From: Griffin, Tim (Contractor)
Sent: 21 March 2026 12:29
To: Altman, Rebecca
Cc: Oliveira, Marta (Contractor); Dyer, Tim; Ellison, Mark
Subject: RM/25/100615 Land West of Burnetts Lane, Horton Heath, (Holme & Homestall) - landscape comments on revised plans

Homestall Landscape GA plan

The Holme Landscape GA plan

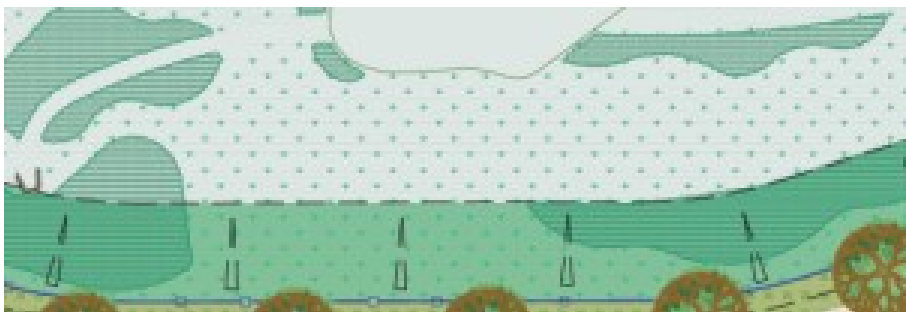
a/ I appreciate the changes that have been made to accommodate my previous comments. The rationalised layout for part of the Green Spine works well. The area at the N end of the Green Spine still looks rather 'busy' and could benefit from further refinement:

As time is short, I would be happy for the final design of this space to be conditioned allowing a further exchange of ideas. Alternatively, I can provide a quick sketch for team consideration. Please advise what you think is best.

b/ For a more consistent landscape character, please change these Structural trees to Avenue trees to continue the effect in front of Plots 208-214.

c/ Please 'loosen' the arrangement of trees in this location since the feature 'square' shown on the original layout has been removed.

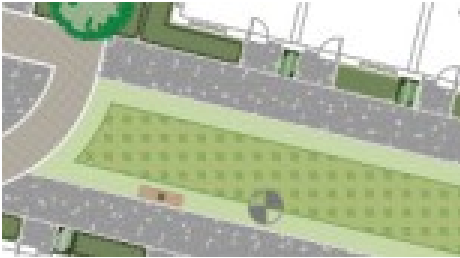
d/ I can't recall if there was a reason to prevent tree planting here:

Is there scope for a line of 3 trees down the middle of the space?

e/ Same area, feature tree to terminate vista?

f/ I am not convinced the run of hedging below between the parking area and path can be delivered as it is in such a narrow strip:

Can the path and play area be pushed E by at least 1m to create a trip 1.5m wide min. for the new hedge? The hdeg is important to soften the parking court.

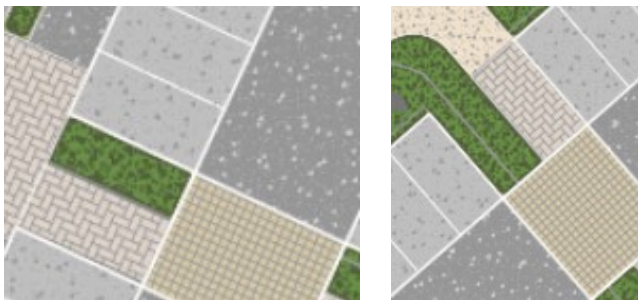
k/ To try and soften the line of this link road could an avenue of trees be introduced both sides of the road, especially as the streetscene to the S is devoid of trees?

l/ I remain a little concerned with the design of this area. Partly due to level changes but also the awkward interface with the adjacent parcel. I think the design of the area needs further work. I would be happy for the final design of this space to be conditioned allowing a further exchange of ideas.

m/ Can we introduce trees in these locations to provide at least some softening of the parking area?

n/ Space for larger single feature tree instead of 2 smaller trees?

p/ Not sure this tree is deliverable?
